DALTON–WHITFIELD
JOINT DEVELOPMENT AUTHORITY

ADDENDUM NO.3 – FEBRUARY 26, 2025

Hamilton Street Workforce Housing Initiative

Pre-Bid Meeting 2/26/2025
Round 2 Questions and answers for:
Hamilton Street Workforce Housing Initiative

DRAWING TITLE
UTILITY PLAN

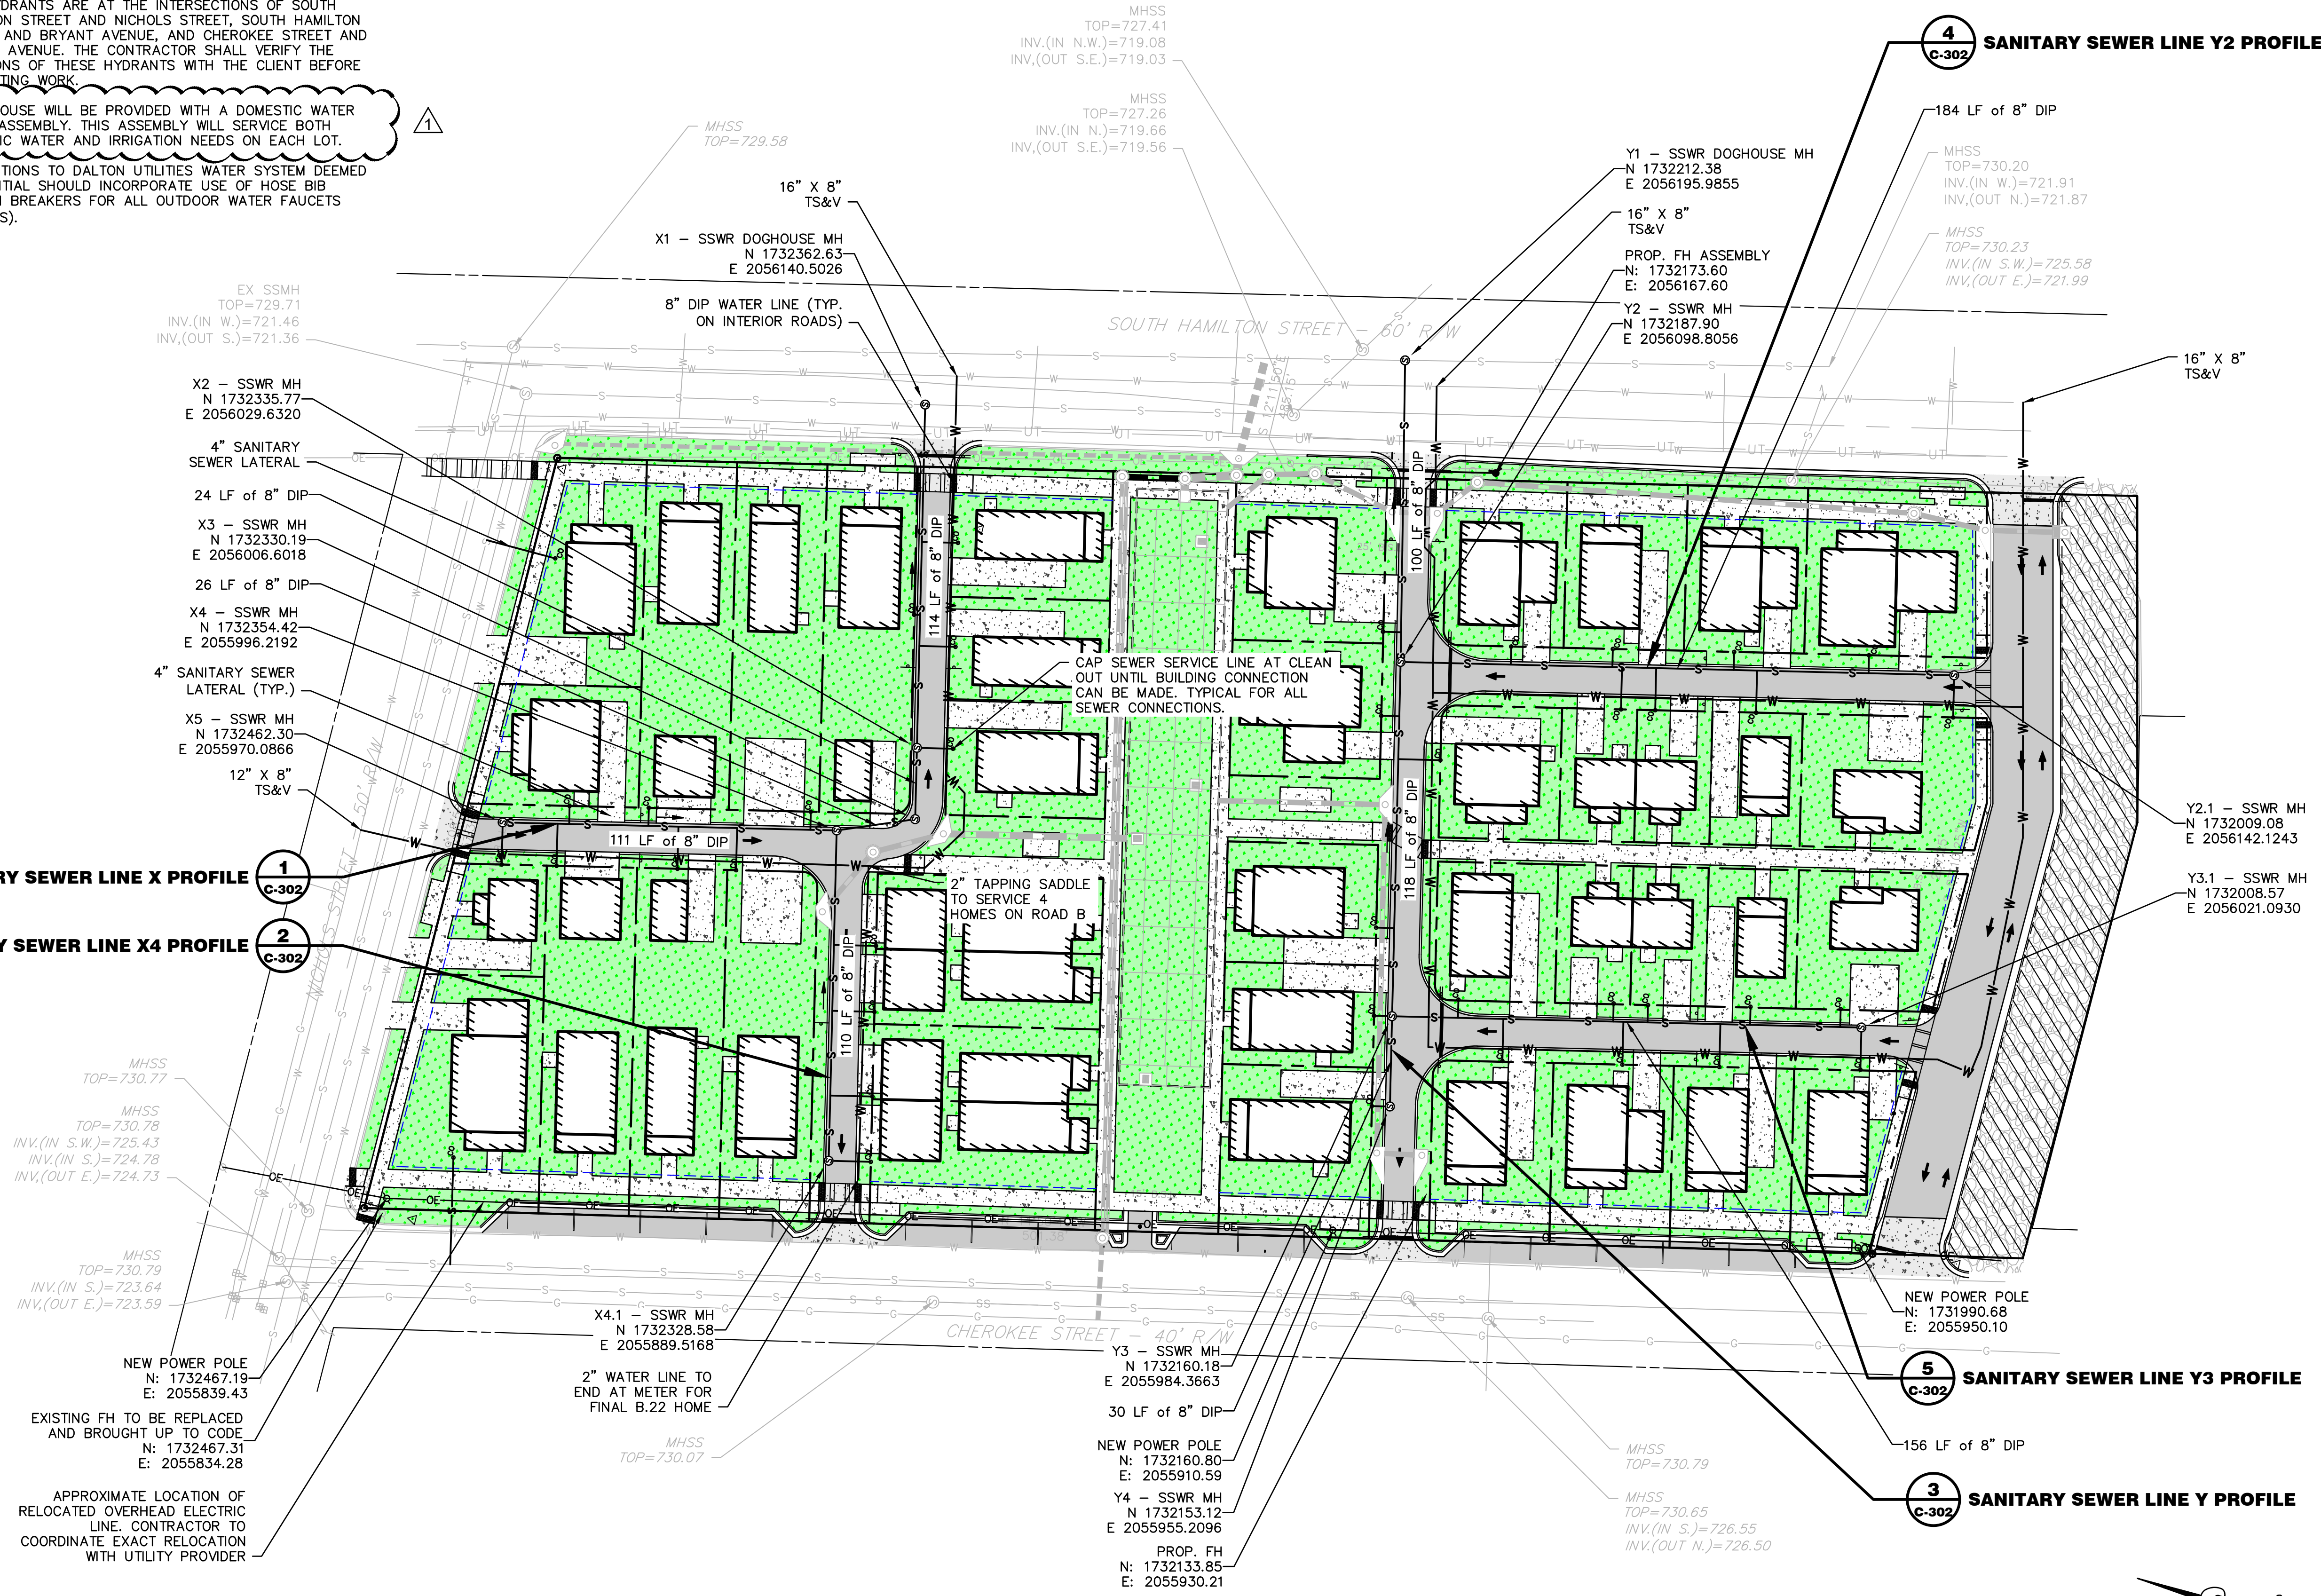
12. With the exception of valves at the water line tie ins/taps, the Utility Plan does not show any proposed 8" gate valves to be installed with the new water line. Please confirm that gate valves are not required since they are not shown on the plans.

13. The Utility Plan does not show the proposed layout for water services. Should each lot be served by a single tap at the main for each lot or will double services be allowed where the main can be tapped once and split at the property line to serve two lots with one tap but 2 separate meters?

DU: In order to isolate shut-offs gate valves will need to be installed @ each road intersection (looking at drawing should be a total of 9)

DU: Each lot will have its own meter but can be yoked from the main service.

DRAWING TITLE
IRRIGATION DETAILS

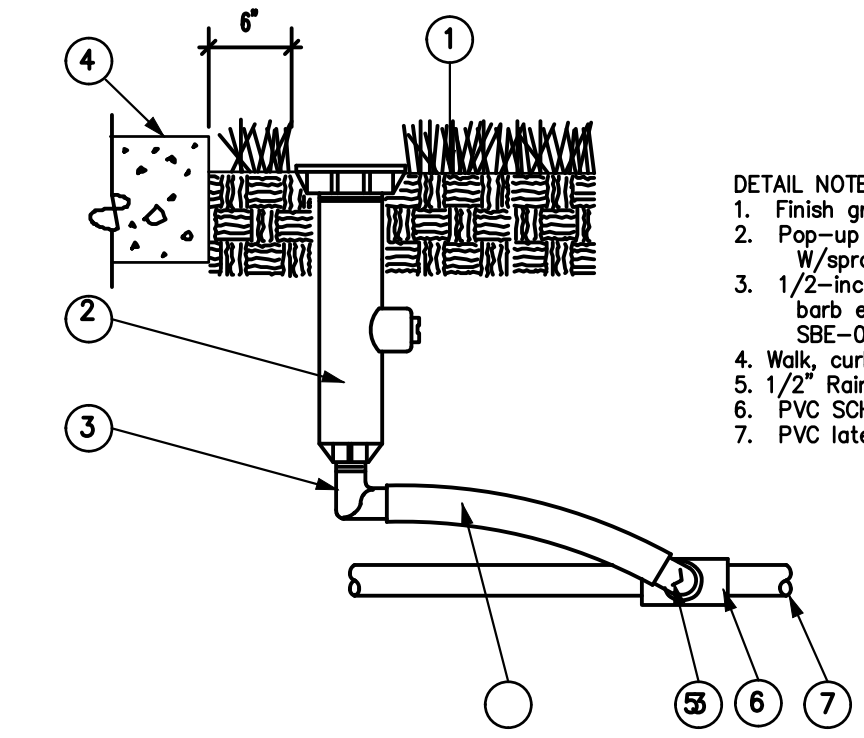
2. In reference to question 2 on the Pre Bid Questions and Answers – The plan only shows a 2” meter, 2” BFP, and a 2” irrigation line around the perimeter of the site. The plan sheet contains various notes on requirements for the irrigation system, including a note that says the Contractor shall design the sprinkler system. It would appear that each contractor could each have a different design and in turn would have a different price for the irrigation system. Considering the plan gives few specifics for the irrigation system would the City consider making the irrigation system an allowance so all bidders are on a level playing field?
The irrigation loop for the entire property (HOA portion of the development) should be priced as an alternate option. This cost will not be used to determine the winning bidder. Please include an alternate price for sprinkler heads and installation of the sprinkler head to the loop.

9. The plans have very few specific details for the requirements for the irrigation system. Without having a planting plan showing the number & locations of trees and various plantings how can a sprinkler system be designed? It seems that a planting plan, at a minimum, would be needed to design and price an accurate irrigation system layout.

10. Note #13 on the Irrigation Plan says the irrigation controller should be located in the Fire/Utility Room of Building. Since there will be no buildings constructed at the time of irrigation install and no apparent common area buildings on the site, please advise where the irrigation controller should be installed and the type of controller required.

See answer for question 2 regarding the irrigation system loop.

If the developer decides to proceed with the option irrigation, assume the irrigation control structure to be located at one of the two mail facilities near the loop.
